TECHNICAL

Update (TU-033)

Hebel PowerPanel^{XL} & PowerPanel⁵⁰ External Walls Slab Edge Detail

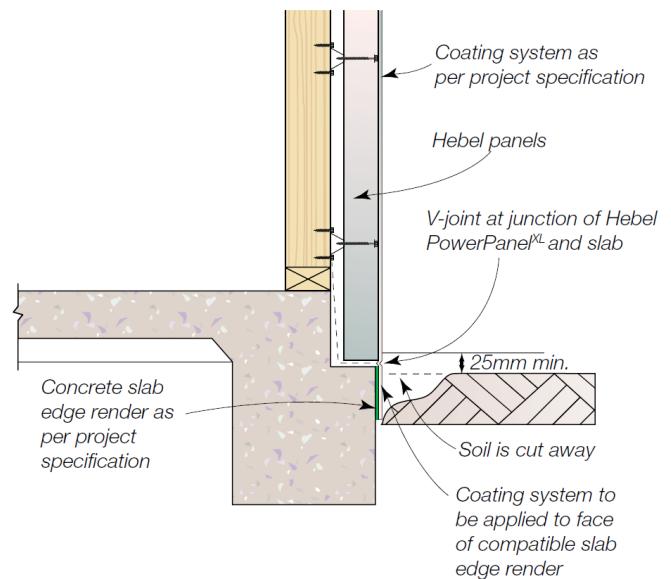
1. The edge of the slab IS NOT rendered, and render is applied continuously to the underside of the overhanging section of the panel.

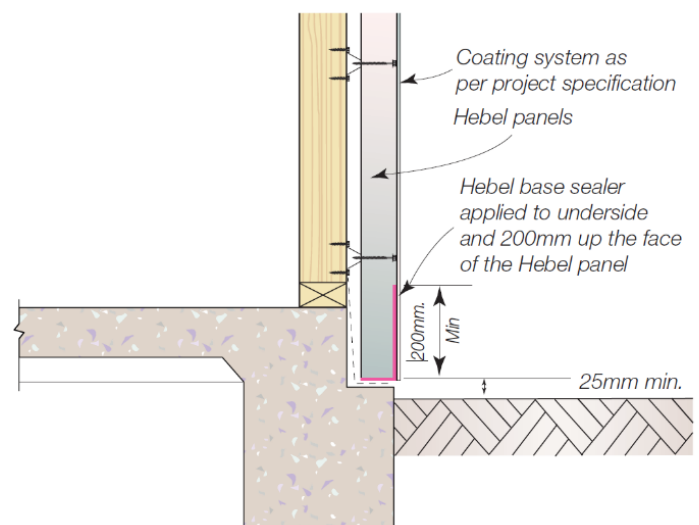
2. The edge of the slab IS rendered and a v-joint is cut into the render at the junction between the base of the panel and the slab.
